Access Compliance Report Public Rights-of-Way (Curb Ramps)

Intersection ID: 43573 Main Street: JOHN_KOLB_DR Cross Street: MARSH_RD Location: SE

ADA ID: 44FCC7463280 Ramp Type: Para Initial Pass/Fail: Fail Overall Compliance: No Severity Score: 13.75

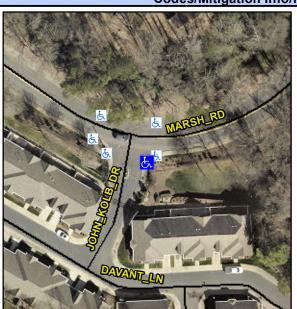
Yellow Surveyor Notes:

LT RP < 5%

N/
N/
PROW/ADA:

R304.5.3, R304.3.2

Possible Solutions:

Remove & Replace Entire Ramp.
